| Type Coffee Vending Machine | Model OPERA TOUCH | N° T.I. 06 - 2022 | |
| Serial Number 22221615 | Subject RECODING MACHINES WITH NEW BOARD | ISSUED FOR (X) | Action Information X |

Back of the current CPU board with **Wi-Fi e Bluetooth** chip **no more available**

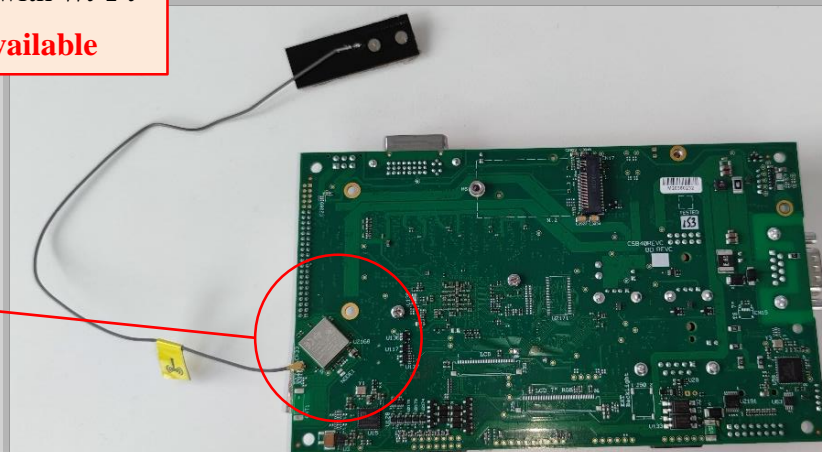
Due to the lack of "Wi-Fi e Bluetooth" chip

A **new** CPU board without "Wi-Fi e Bluetooth" chip has been introduced in production and as spare (temporarily)

Wi-Fi and Bluetooth chip

Important note: to ensure connectivity functionality, the introduction of a **USB dongle** is being approved. Its introduction and availability will be communicated with a supplementary notice.

- ✓ The **pre - modification CPU Opera Touch board** with "Wi-Fi e Bluetooth" chip, currently not available due to the lack of the component mentioned above, it keeps the spare code: **261137**
- ✓ The **new CPU Opera Touch board** without "Wi-Fi e Bluetooth" chip has the following spare code: **265555 sap 55124947**
